1981 FL/FX MODELS SERVICE INFORMATION

REAR BRAKE — FL/FX MODELS

Figure 1. 1981 FLH Rear Brake Caliper

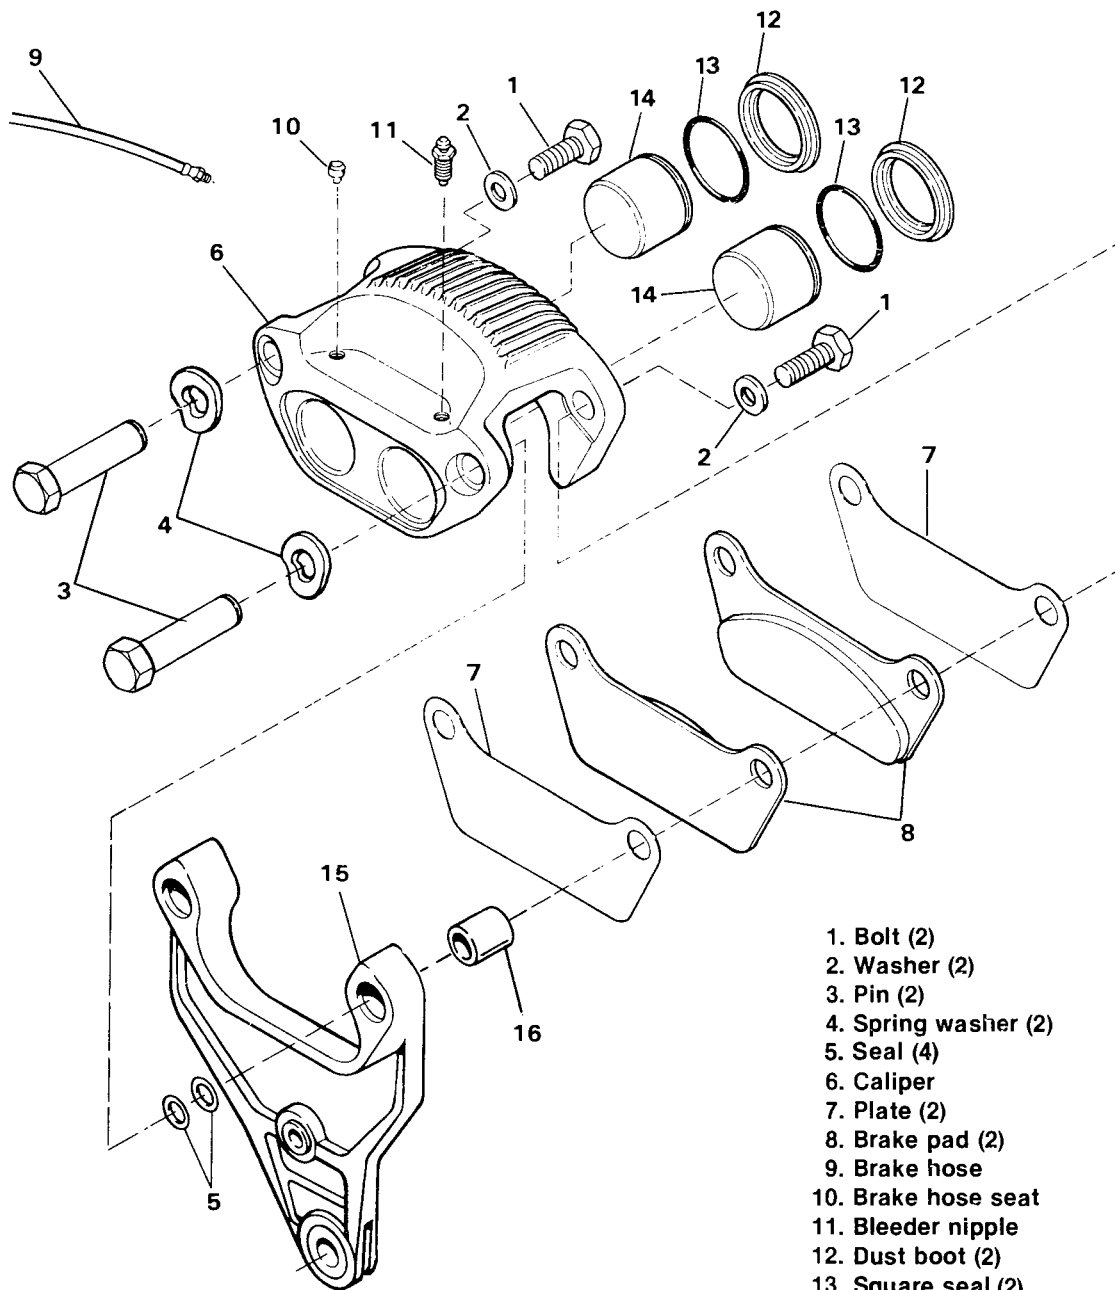
See Figure 1. 1981 FLH models are fitted with a new dual piston rear brake caliper assembly similar to that used on the FLT. Some important differences between the FLH and FLT brakes should be noted. The mounting brackets are different and the FLH caliper is fitted with square seals on the mounting pins rather than with round O-rings. The bleeder fitting on the FLH caliper is in a different position than on the FLT caliper. Also, the FLH caliper does not have brake pad springs. Do not install these springs on the FLH calipers as they may cause the pads to rub on the disc when the brake is not applied. The FLH 12-inch rear disc and plate are also new and are not interchangeable with the FX or FLT disc and plate.

Figure 2. 1981 FX Rear Brake Caliper

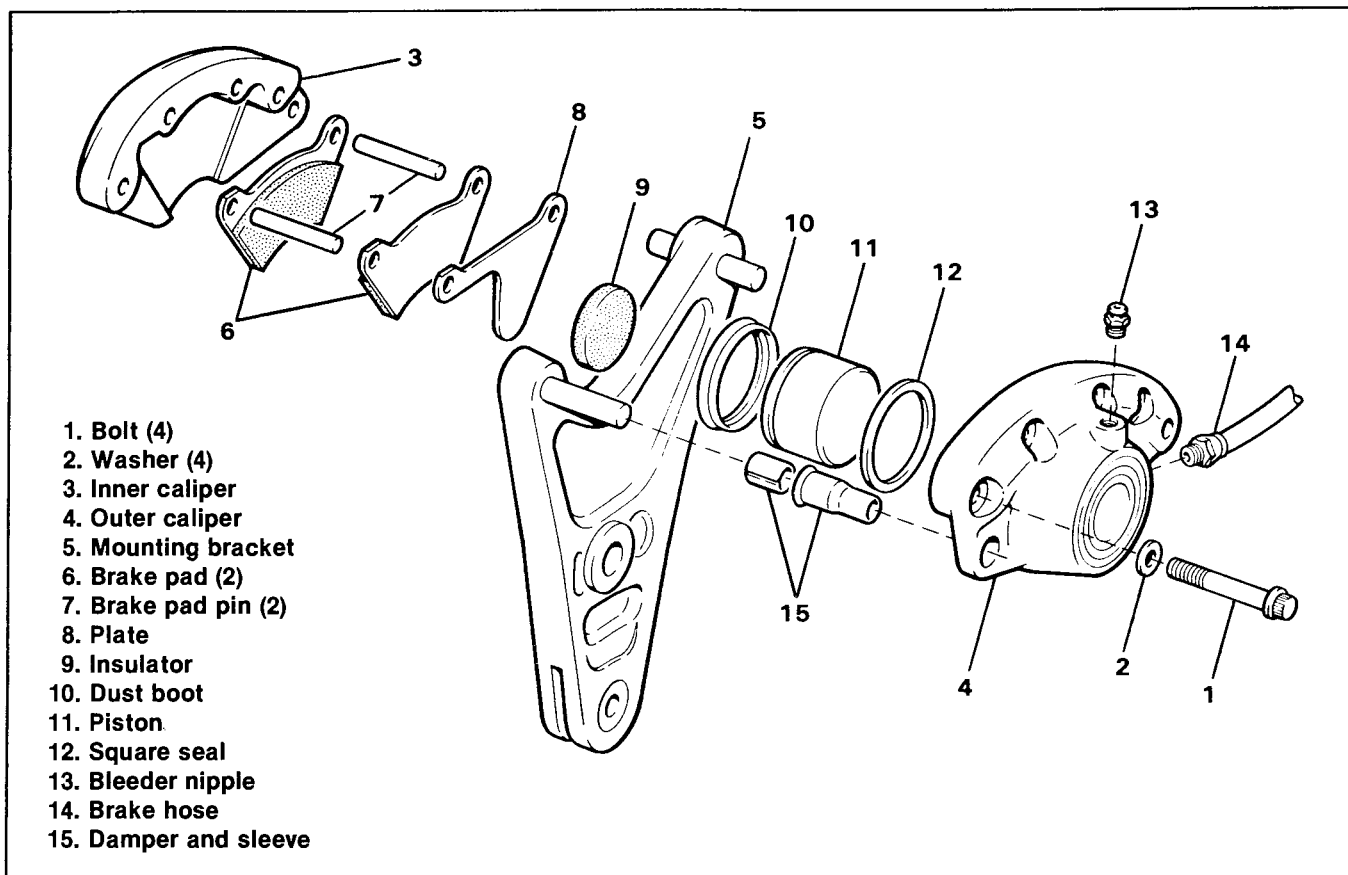
See Figure 2. 1981 FX models also have a new rear brake caliper and mounting bracket. The caliper is sup-

ported both front and rear on mounting pins which are pressed into the bracket. These pins are not removable. The rear mounting hole in the outer caliper half is fitted with a rubber damper and a nylon sleeve which are replaceable as a set. All FX models are equipped with a new 11½ inch rear disc.

Both FL and FX calipers feature the square seal piston design introduced on mid 1980 models. For best operation and maximum brake pad life, the mounting pins of both rear calipers should be coated with a light film of Harley-Davidson ANTI-SEIZE, Part No. 99632-77, whenever the calipers are serviced.
